2026-10-13 RFI:
• PHASE 1 CIVIL PLANS - UPDATED
LOT NUMBERING PER FINAL PLAT.

PROJECT:
WILDFLOWER - PHASE 1
VILLAGE OF SUSSEX, WISCONSIN
BY: JBJ COMPANIES, INC.
W178 N9912 RIVERCREST DRIVE, SUITE 101
GERMANTOWN, WI 53022

DESCRIPTION:
OVERALL
MASTER
GRADING PLAN

C2.8

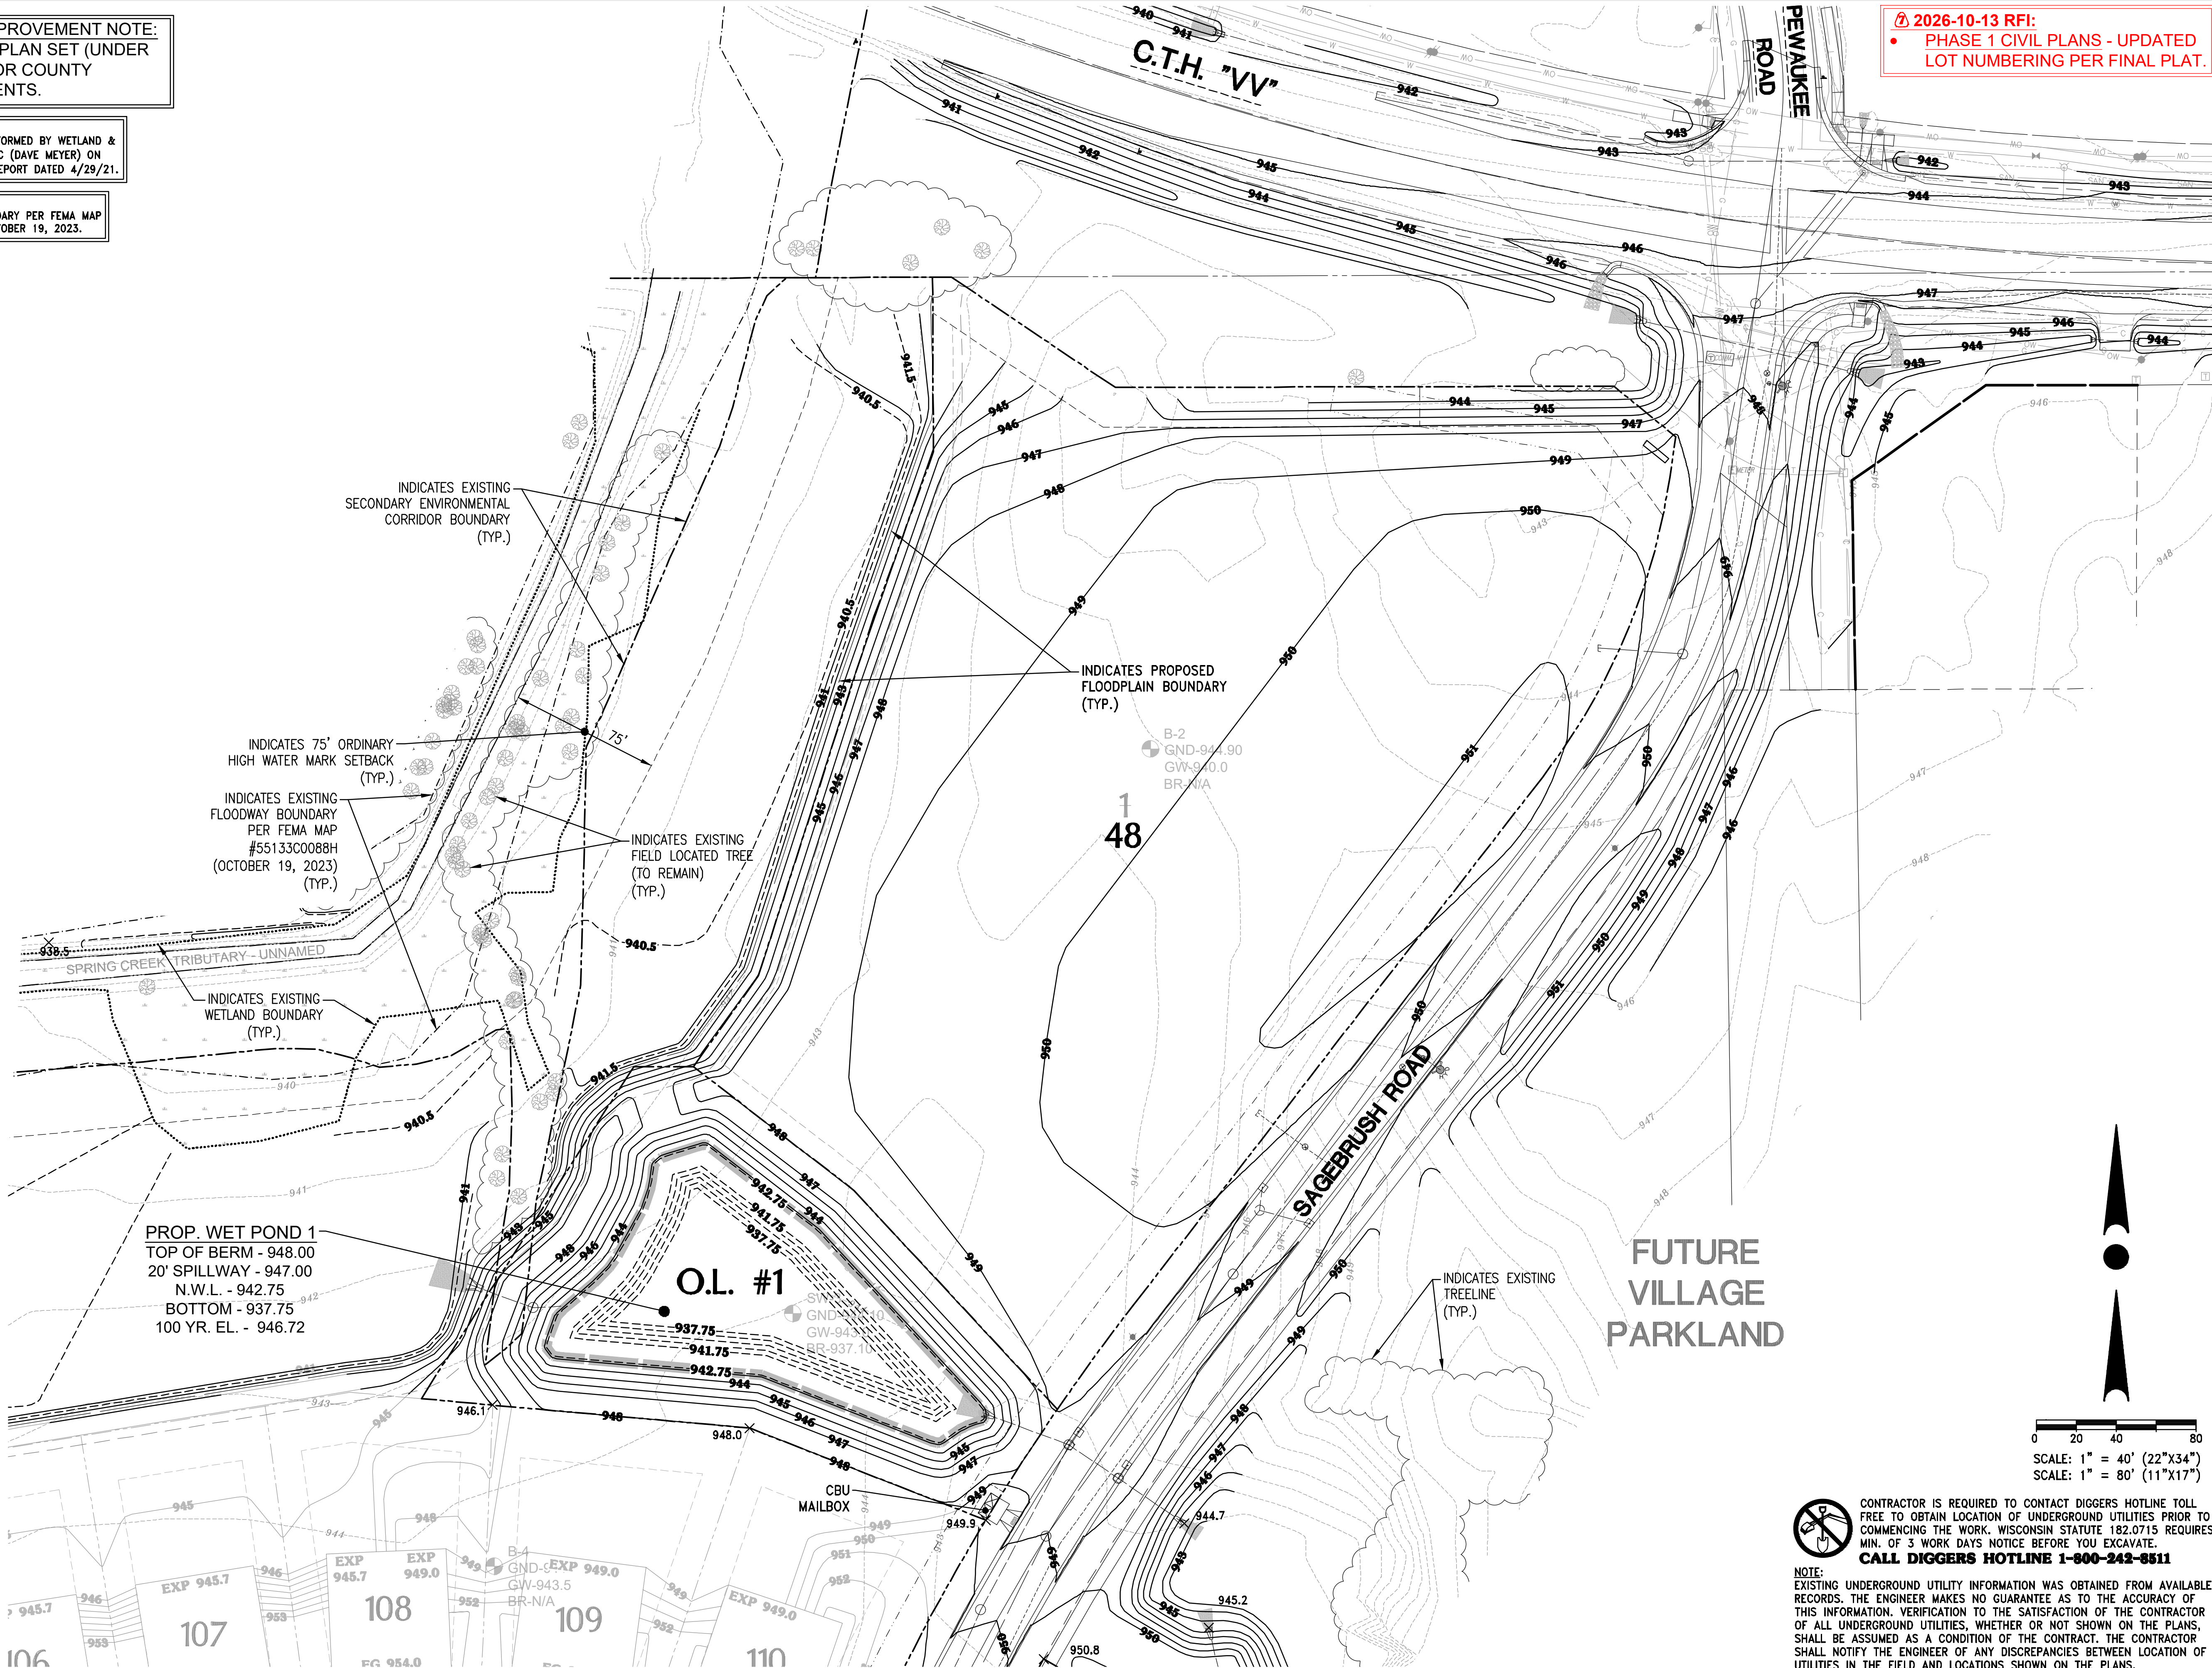
2026-10-13 RFI:
PHASE 1 CIVIL PLANS - UPDATED
LOT NUMBERING PER FINAL PLAT.

SHEET
C2.9

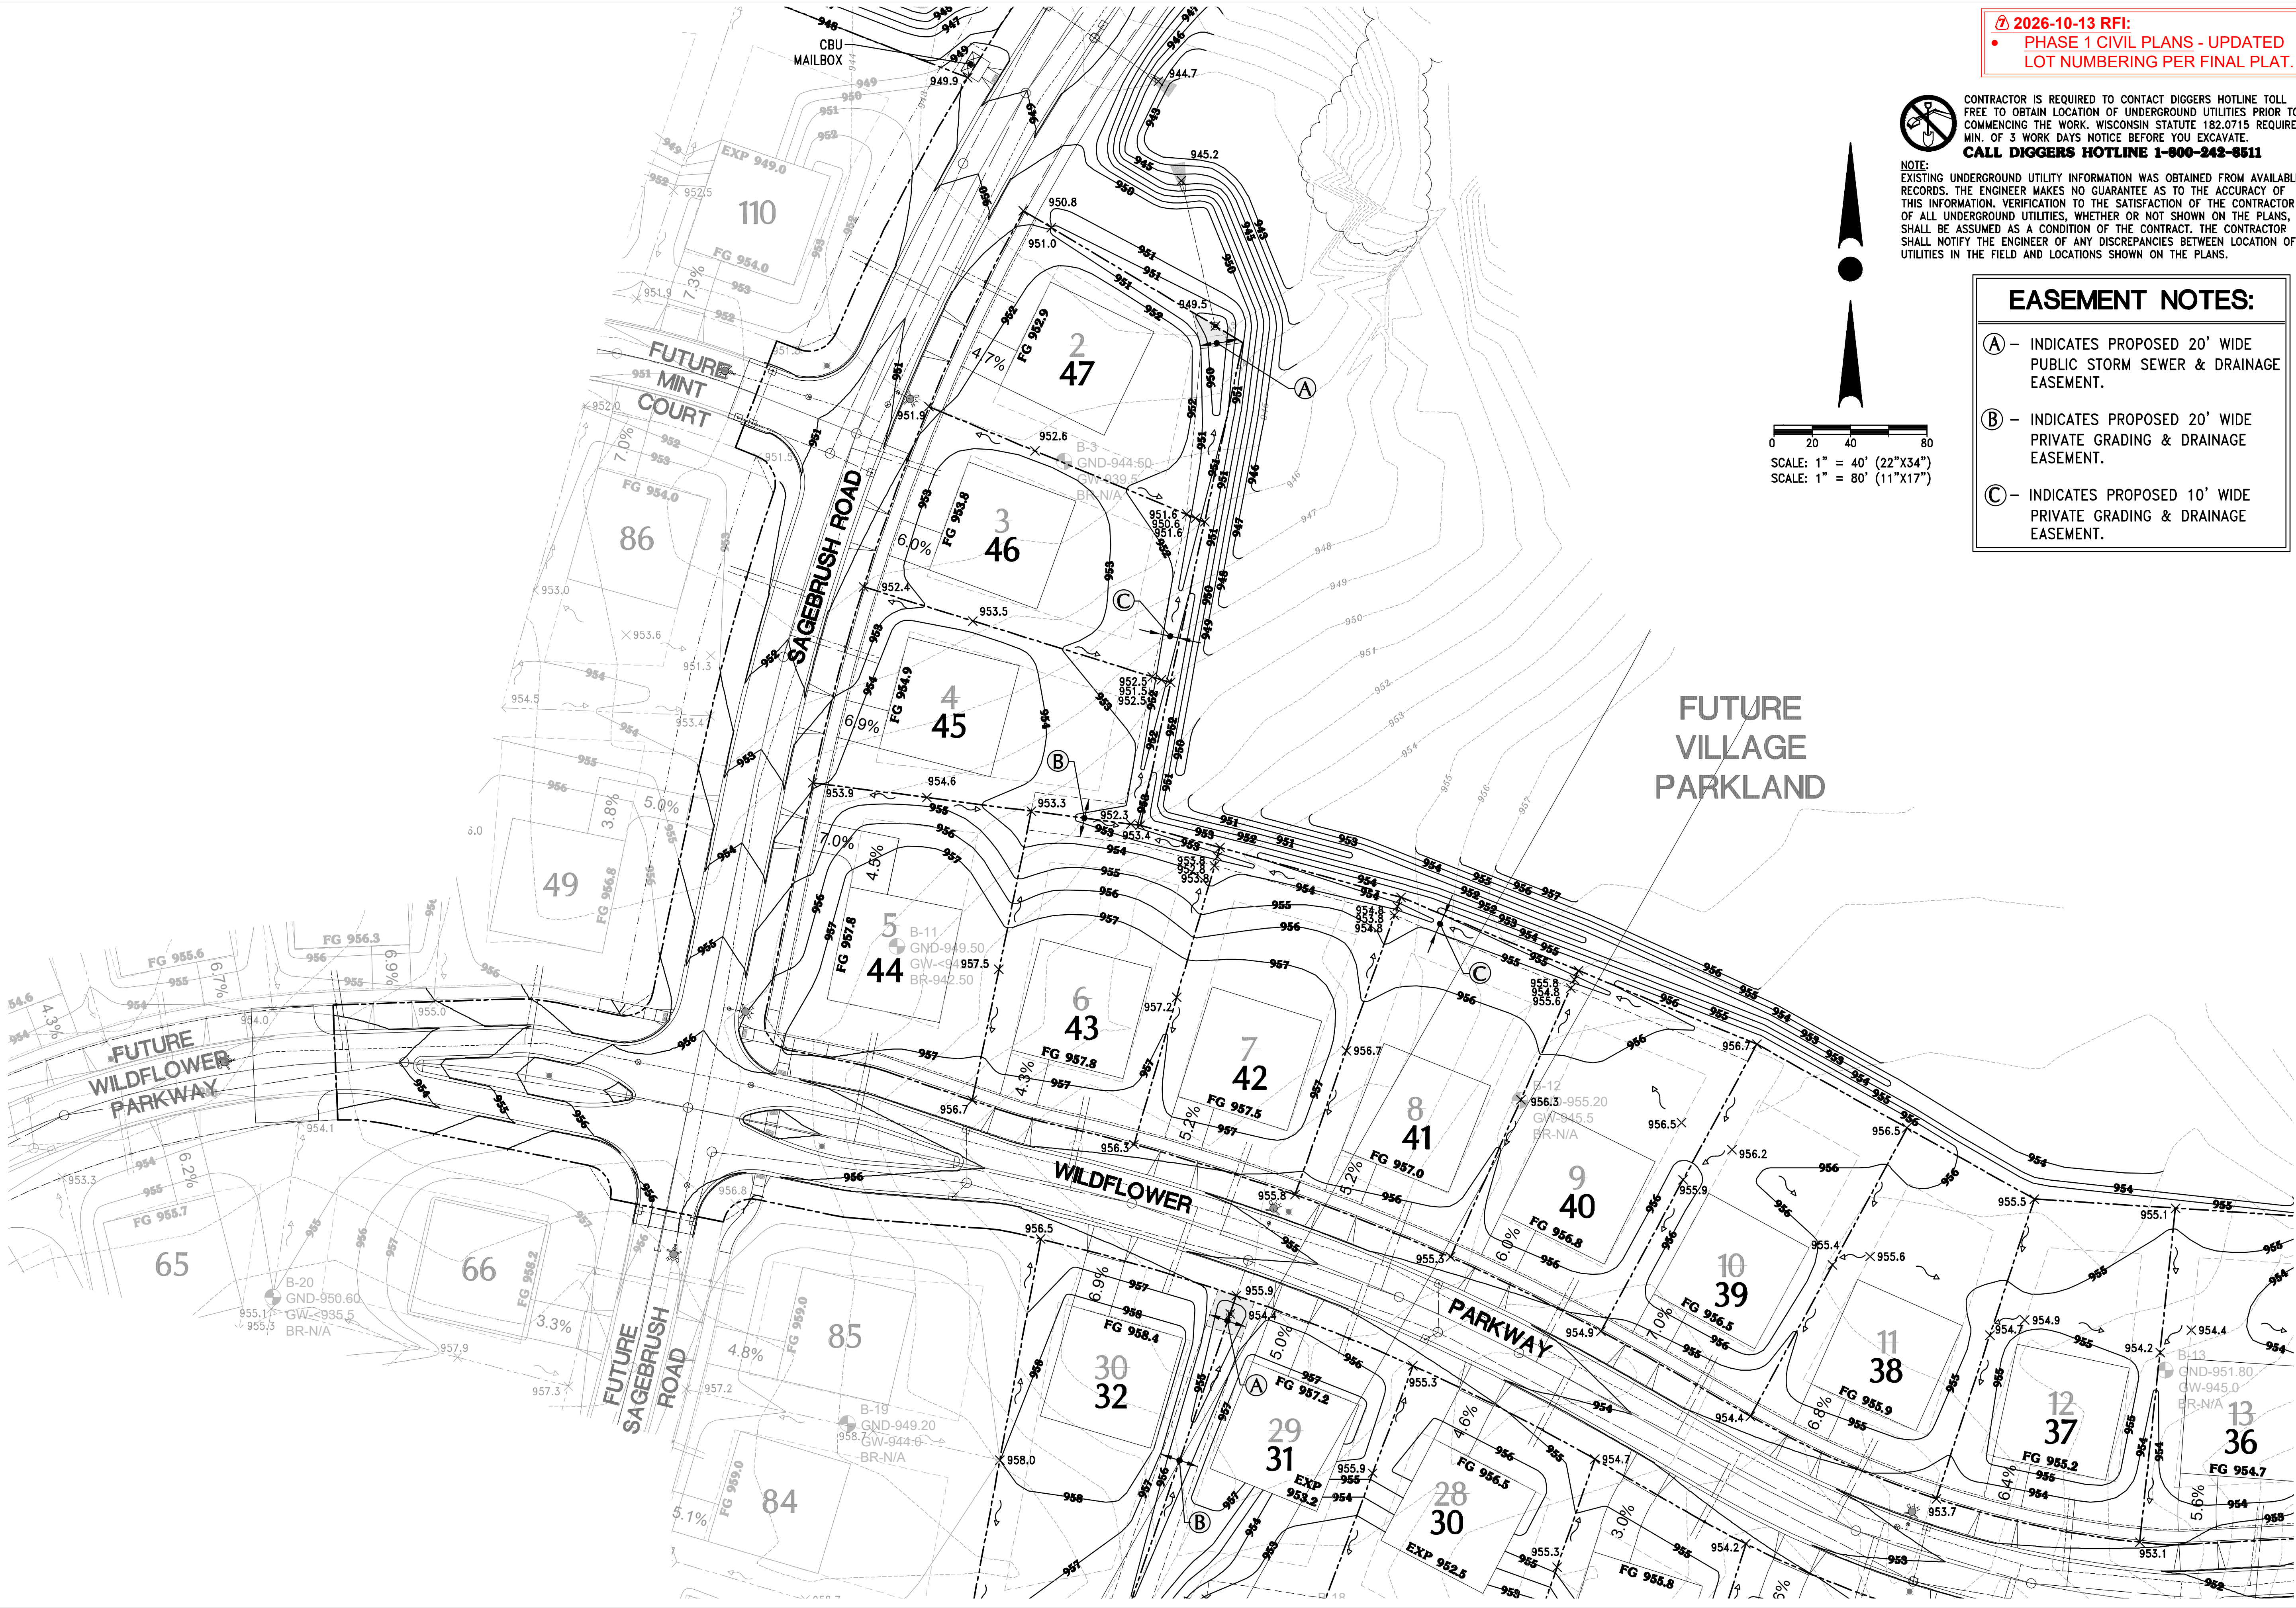
2026-10-13 RFI:
• PHASE 1 CIVIL PLANS - UPDATED LOT NUMBERING PER FINAL PLAT.

C2.10

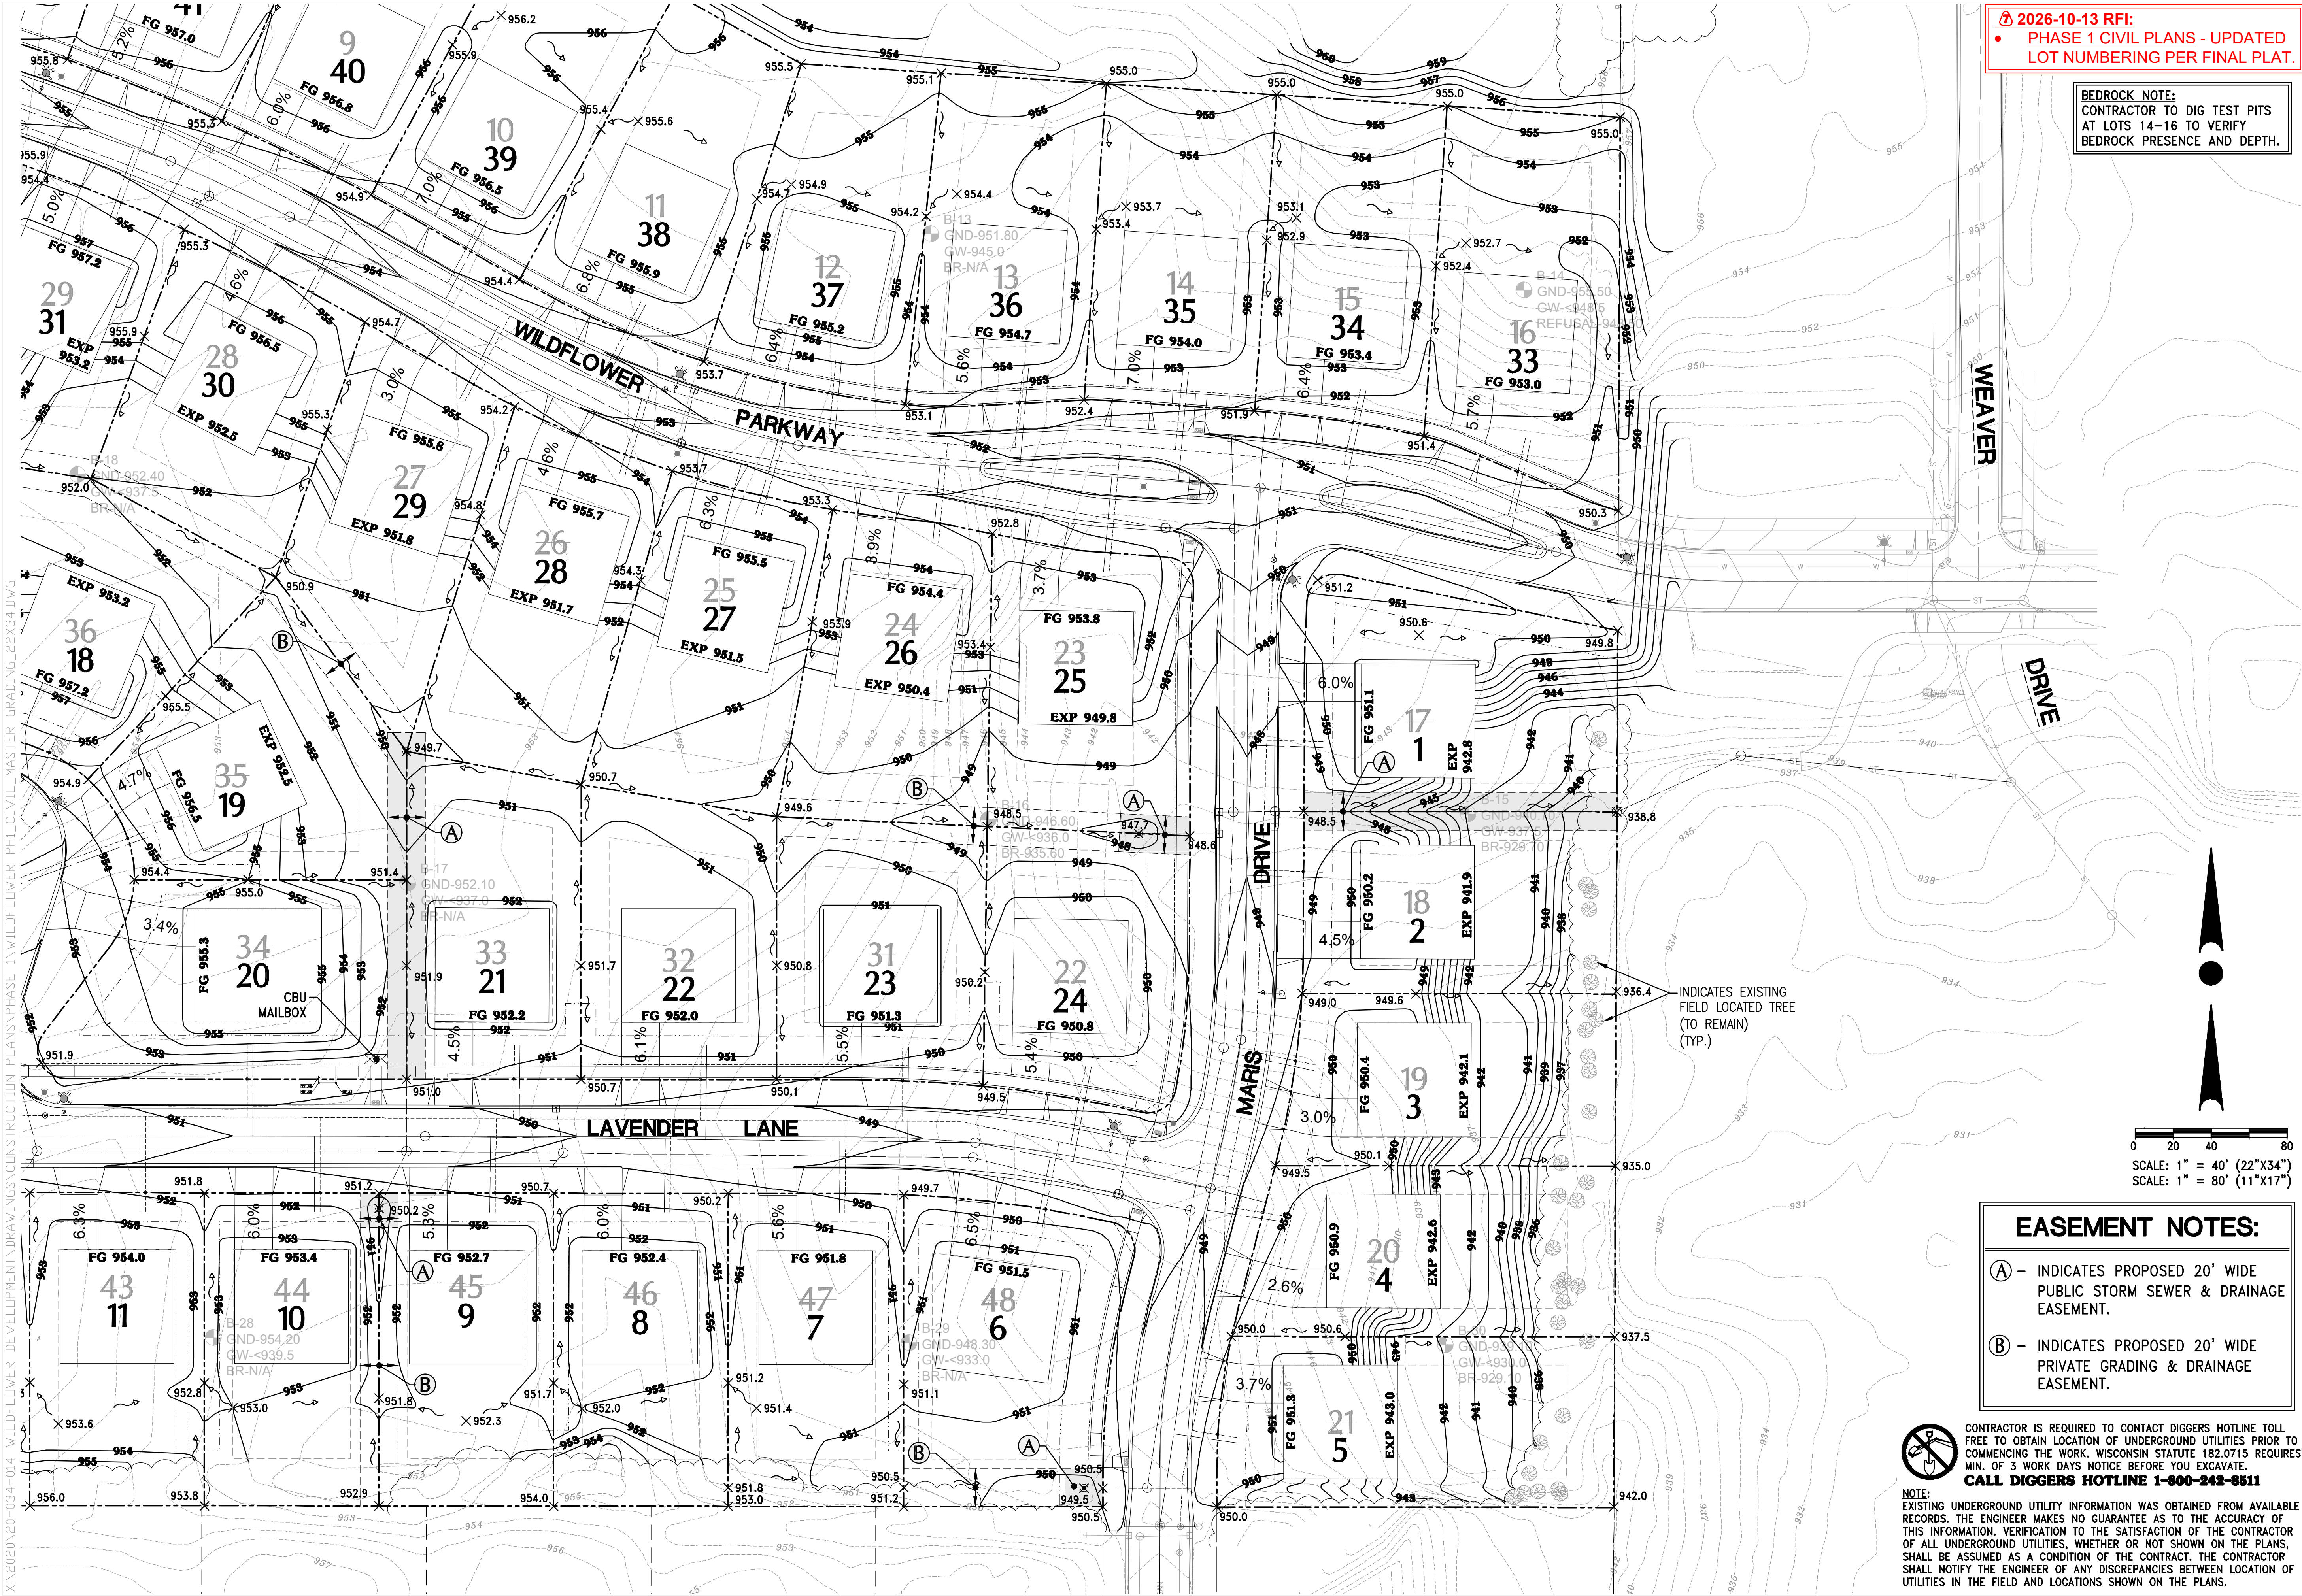
⑦ 2026-10-13 RFI:
• PHASE 1 CIVIL PLANS - UPDATED
LOT NUMBERING PER FINAL PLAT.
